Design Review Board Meeting
February 4, 2016
Agenda Item: **3**

STAFF REPORT

Subject: 2370 Paradise Drive; File No. VAR2015023/DR2015148; Site Plan and Architecture Review for Construction of a New Single-Family Dwelling, with Variances for Excess Lot Coverage and Excess Fence Height

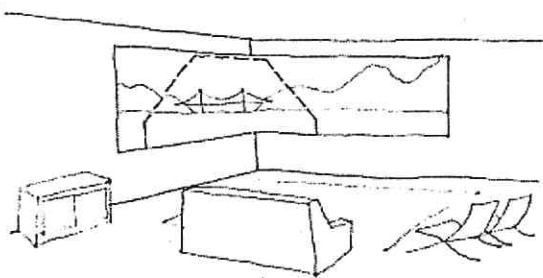
The profile of the proposed house would be similar to that of the existing house on the site. Most of the roofline would not exceed the height of the existing house and the proposed dwelling would not extend beyond the footprint of the existing structure in locations that would affect views from neighboring properties. The roofline would not appear to intrude into views from any homes uphill from the site. The lot directly across the street from the subject property is currently vacant, but future development of this site would likely be similar to that of other homes on this side of Paradise Drive, which have been designed to capture views at higher floor levels above the homes across the street.

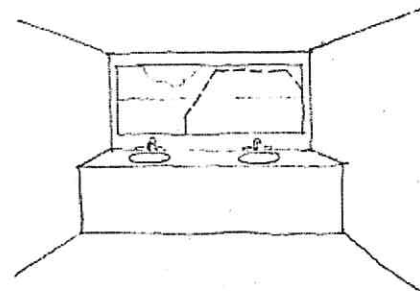
Goal 3, Principle 7 (A) of the Hillside Design Guidelines states that “view protection is more important for the primary living areas of a dwelling (e.g. living room, dining room, family room, great room, kitchen, and decks associated with these rooms) than for less actively used areas of a dwelling (e.g. bedroom, bathroom, study, office, den).” The raised roofline would intrude into the views from the kitchen and dining room of the home at 2380 Paradise Drive.

NO

• PROPOSED STRUCTURE
BLOCKS LIVING ROOM VIEW

• GREAT IMPACT ON
LIVABILITY

• PROPOSED STRUCTURE
BLOCKS BATHROOM VIEW

• LITTLE IMPACT ON
LIVABILITY

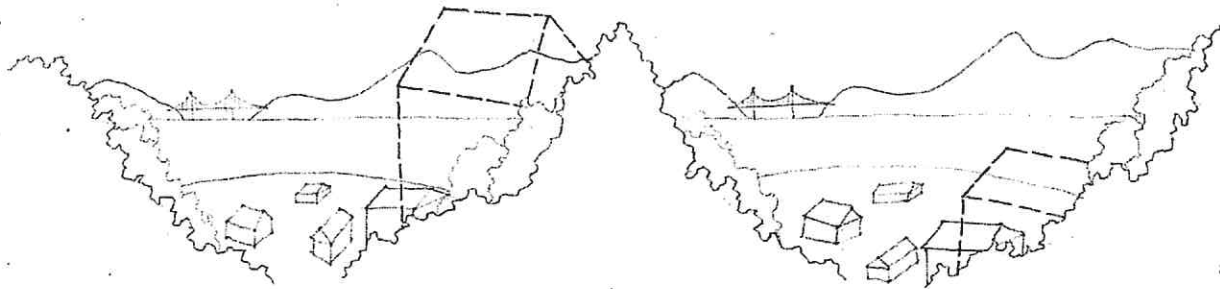
Goal 3, Principle 7 (C) of the Hillside Design Guidelines states that “horizon line is [the] most sensitive part of [a] view, then foreground, then middleground. If possible, avoid cutting [the] horizon line of a neighbor’s view.” The proposed raised roofline would cut

into the horizon line of the Marin Headlands and below the Golden Gate Bridge for the home at 2380 Paradise Drive.

6. BLOCKAGE OF CENTER OF VIEW MORE DAMAGING THAN BLOCKAGE OF SIDE OF VIEW.

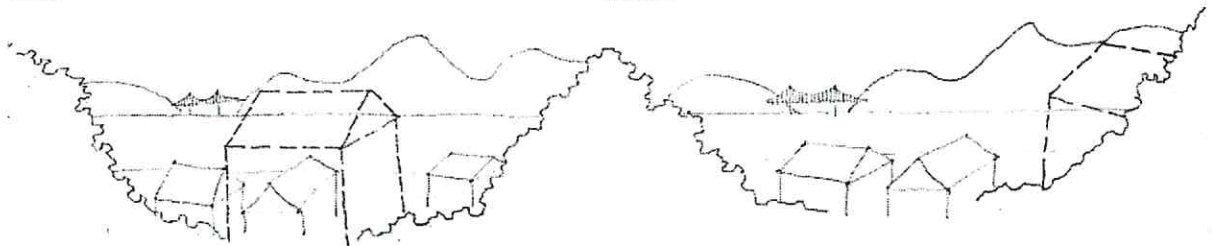
Goal 3, Principle 7 (C) of the Hillside Design Guidelines states that “blockage of center of [the] view [are] more damaging than blockage of [the] side of [the] view.” The raised roofline would intrude into the far right side of the view from the home at 2380 Paradise Drive.

• PROPOSED STRUCTURE
BLOCKS CENTER OF VIEW

• PROPOSED STRUCTURE
BLOCKS SIDE OF VIEW

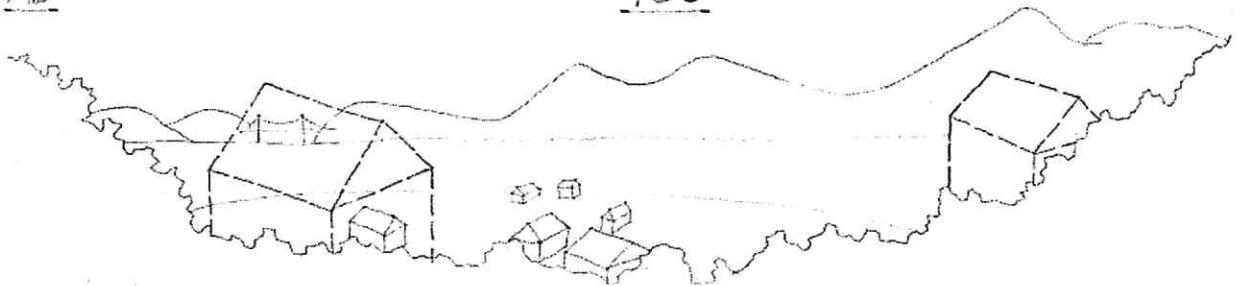
Goal 3, Principle 7 (D) of the Hillside Design Guidelines states that “blockage of important object in the view (Golden Gate Bridge, Belvedere Lagoon, Sausalito, Angel Island) is more difficult to accept than blockage of other, less well-known landmarks.” The raised roofline would intrude into the views of the Golden Gate Bridge from the kitchen of the neighboring home.
